## Technical Note

Project No: ITL09289  
Project Title: Land at Appledore Road, Tenterden  
Title: Planning Application Highways Response  
Ref: NM/BC/ITL09289-024B TN  
Date: 14 April 2020

**Image 4.1 – Existing Eastbound Bus Stop along Woodchurch Road**

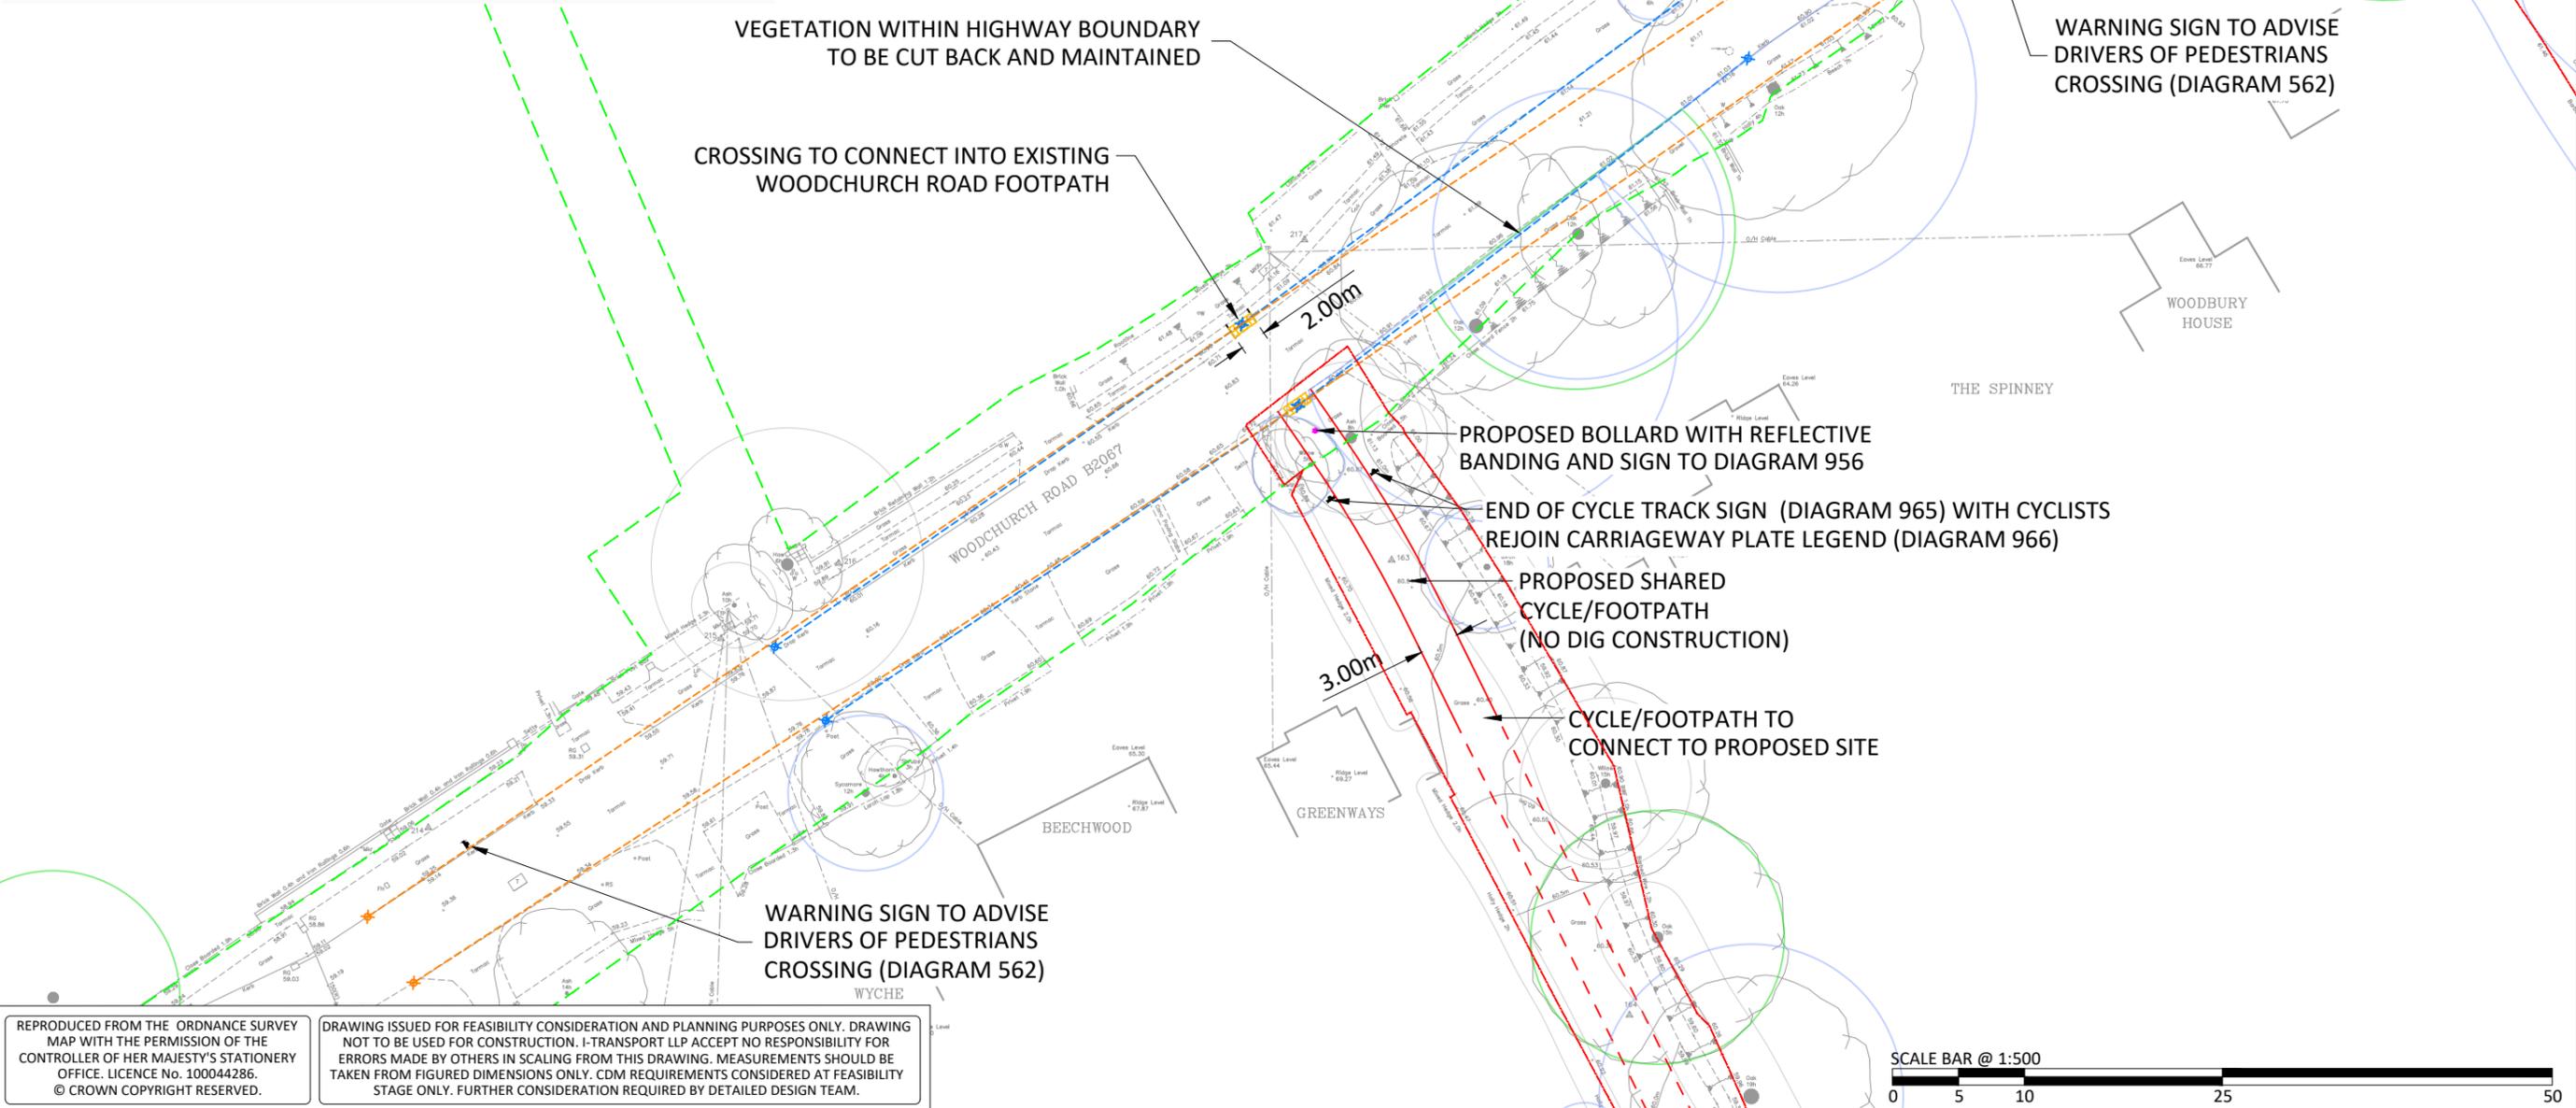
- 4.1.6 It is noted that the existing bus stop for the 2A eastbound route includes a new pole and flag with no shelter provided (shown in Image 4.1 below); this is common in Tenterden and reflects the character of the existing streets, including bus stops along Appledore Road, Oaks Road, Ashford Road (A28) and the High Street.

- 4.1.7 To be in keeping with the surrounding streets, and to ensure that the character of the surrounding streets is not adversely impacted, it is proposed that bus shelters are not provided at the existing or proposed bus stops by the junction of Woodchurch Road/Beacon Oak Road. As noted within the following section, the demand created by the proposal is also of insufficient volumes to warrant the need for new bus stop infrastructure.
